Accessibility Design Review Report

Nepean Village Outdoor Precinct
Cnr of Station & Woodriff Street Penrith

Prepared for: Vicinity Centres

Phase: DA

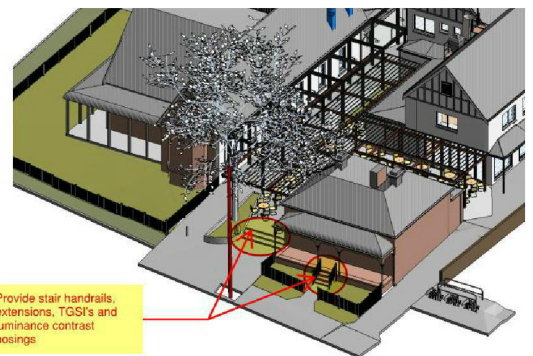
- Stair access via Station Street.
 - Two stair access is noted to be provided:
 - Stair access to the seating courtyard
 - Stair access to historical structure is noted to be existing
 - As part of the accessible path of travel both stairways shall be provided with handrails to both sides and extensions with TGSI's and stair nosings.

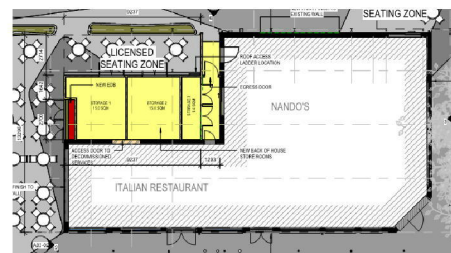
- Internal access corridor within this development consist only to exempt areas to the store room and roof.
- This corridor is not required to be accessible and will not be required to comply with AS1428.1-2009 – refer to areas highlighted in yellow

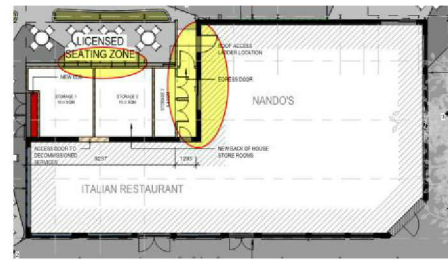
- Internal doorways are not required to be accessible as they are to exempt rooms:
 - Store 1,2,3
 - Door to roof access Ladder

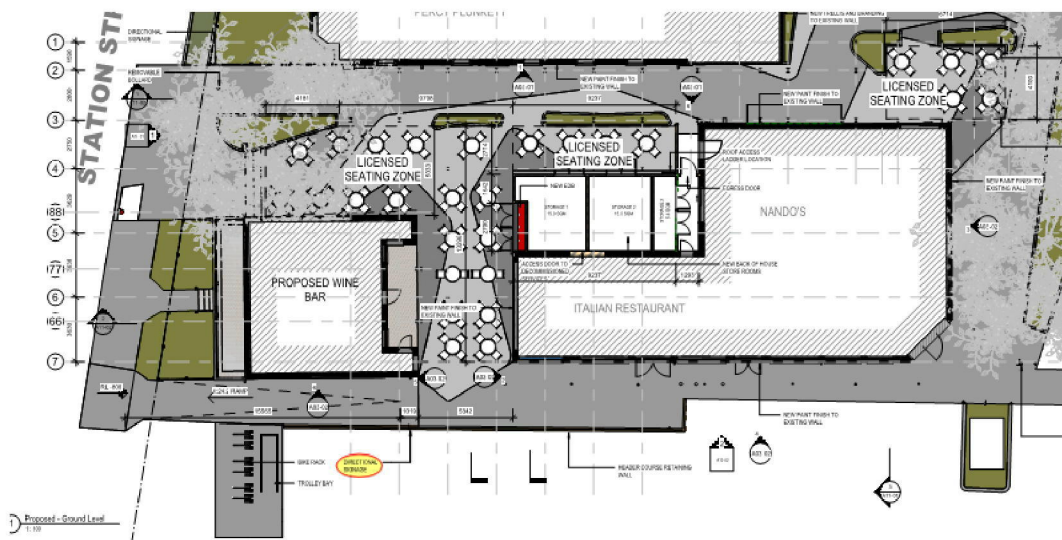
- It is noted that directional signage is located adjacent to the 1:24.2 walkway
